To: T10 Technical Committee
 From: Rob Elliott, HP (elliott@hp.com)
 Date: 21 April 2006
 Subject: 06-166r4 SAS-2 Restrict access to SMP ZONED BROADCAST function

Figure 1 — ZONED BROADCAST from a rogue initiator port

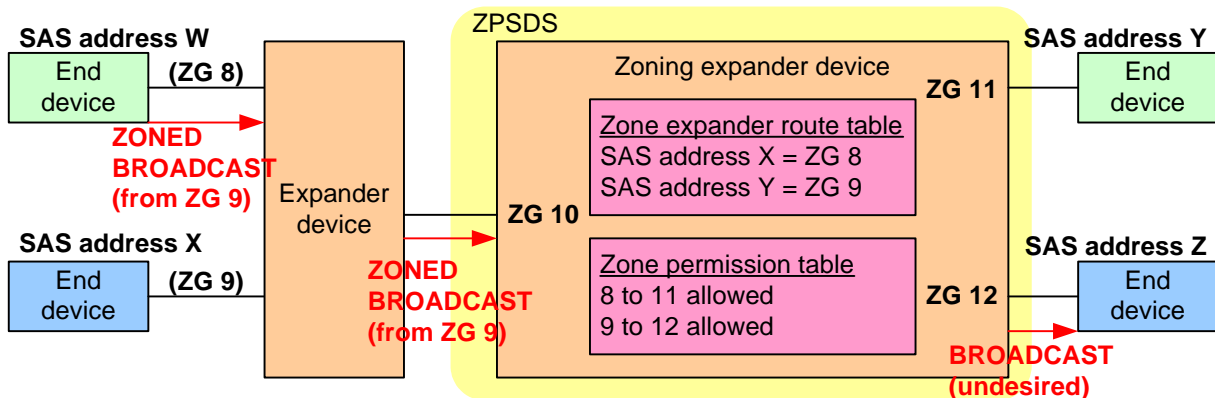
In sas2r03, the function can be sent by any SMP initiator port that has access to the expander device. This means an SMP initiator port in one zone group can introduce BROADCAST traffic into other zone groups (see figure 1), which somewhat defeats the purpose of zoning. It cannot introduce an OPEN to another zone group, because the expander to return OPEN_REJECT (ZONE VIOLATION) using the address resolved method.

Access needs to be restricted so SMP initiator ports cannot sneak BROADCAST traffic into other zone groups unless they have permission, making it the same as OPEN traffic.

Figure 2 — BROADCAST escaping zone

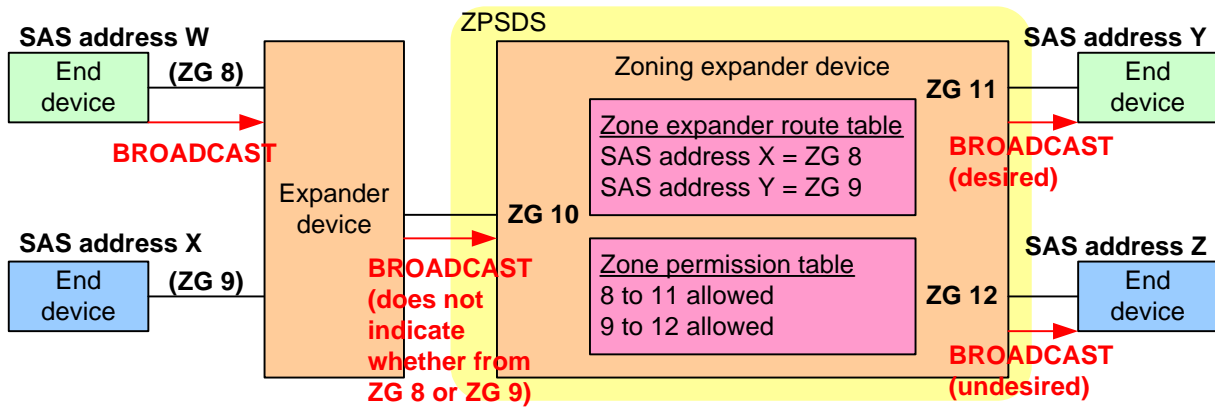
With the “zone address resolved” mode, an expander phy on the boundary of the ZPSDS that is attached to another expander device may be the entry point for traffic from devices in more than one zone group. However, since BROADCAST primitives do not carry source zone group information, an incoming BROADCAST primitive must be considered to have come from any of those zone groups. The expander device must treat it as coming from all the possible source zone groups and forward it to all destination zone

groups to which all the source zone groups on that expander phy have permission (see figure 2). This is undesirable.

A mechanism should be defined to allow the expander device outside the ZPSDS to identify the source zone group of the BROADCAST so it can be forwarded only to the proper destination zone groups. This cannot be perfect (since the expander device is not trusted), but it can limit the extent of the BROADCASTs if it is behaving (and anyway is restricted only to the zone groups that are sharing the door into the ZPSDS).

Figure 3 — BROADCAST kept in zone

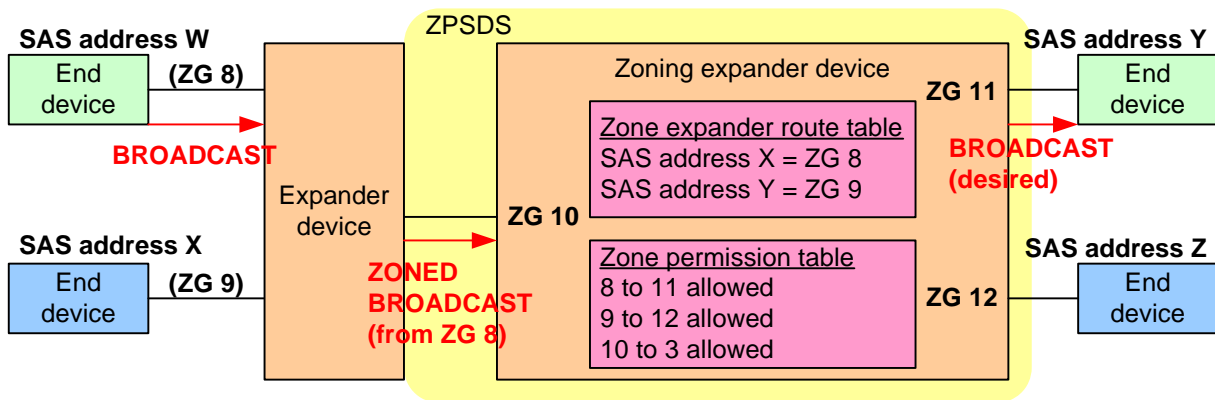
A new zone group 3 is proposed for this purpose. The zone permission table must indicate the SMP initiator port has access to zone group 3 for the SMP ZONED BROADCAST function to be allowed. This allows an external expander device, if its own source zone group has access, to use SMP ZONED BROADCAST (see figure 3).
